SERVICE BULLETIN

Product:	:LCD monitor	Bulletin No.	:	02-C/M-E0069

Model : GH17L,GH17E,GH17V~ (exclude GH17P) **Bulletin Date :** 06-May-02

SUBJECT: Before service to prevent Inverter failure problem.

BN44-00064A INVERTER (OLD VERSION)
Blue tape => Replace with new inverter

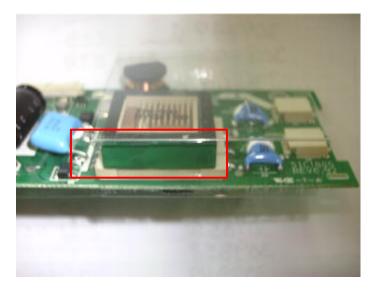
But BN44-00064A inverter can be fail because of high voltage discharge to trans coil.

Symptom of failure : Trans coil burnt, smoke => dim display or No video.

If inverter number is BN44-00064A(blue color), replace with BN44-00041A inverter.

BN44-00064A INVERTER (IMPROVED VERSION)
Yellow or geen tape => Do not need to replace.

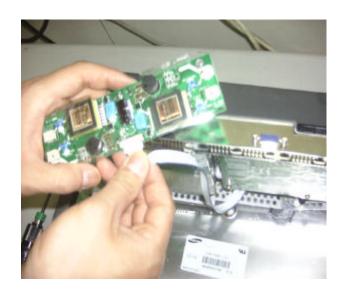
- * 64A inverter have 3 version (Blue, Yellow, Green tape around trans mounted on inverter board)
- Blue tape : Replace.
- Yellow or Green tape : No need to replace (improved version)
